ADDENDUM NUMBER 1

Issued: July 2, 2008

Water Transmission System Air Valve Upgrade - Phase 1

D. Drawing Number D-4:

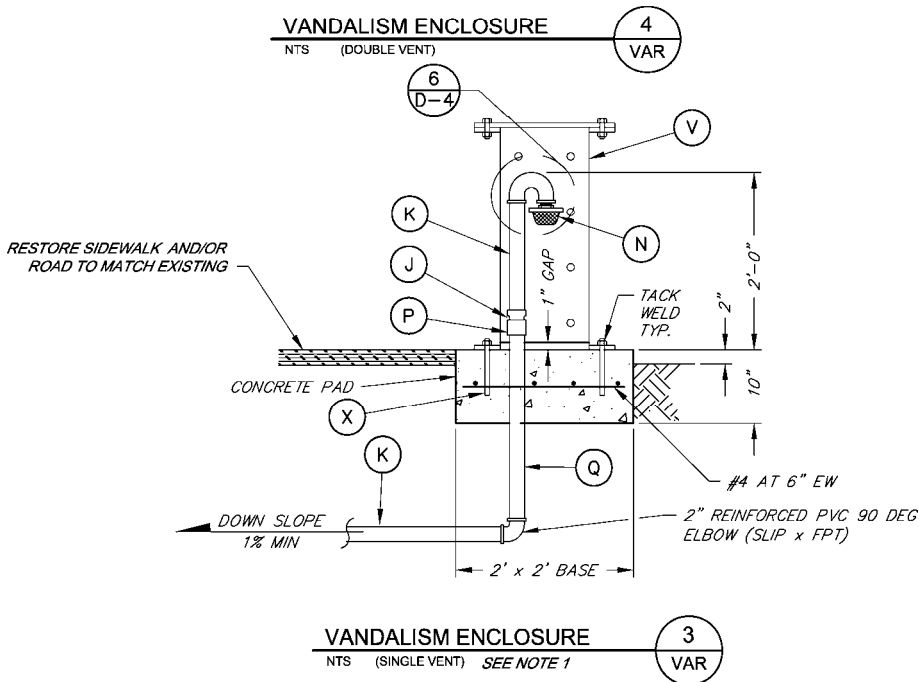
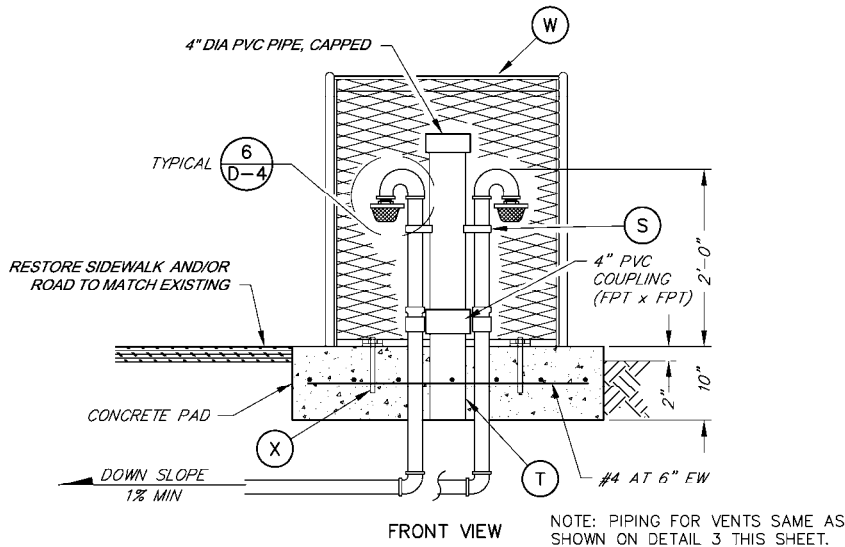
1. In the table entitled LIST OF MATERIALS COMBINATION AIR VALVE VENT PIPING, delete Item N description and replace with the following:
SUCTION STRAINER
2. Delete details 3 and 4 and replace with the following details 3 and 4:
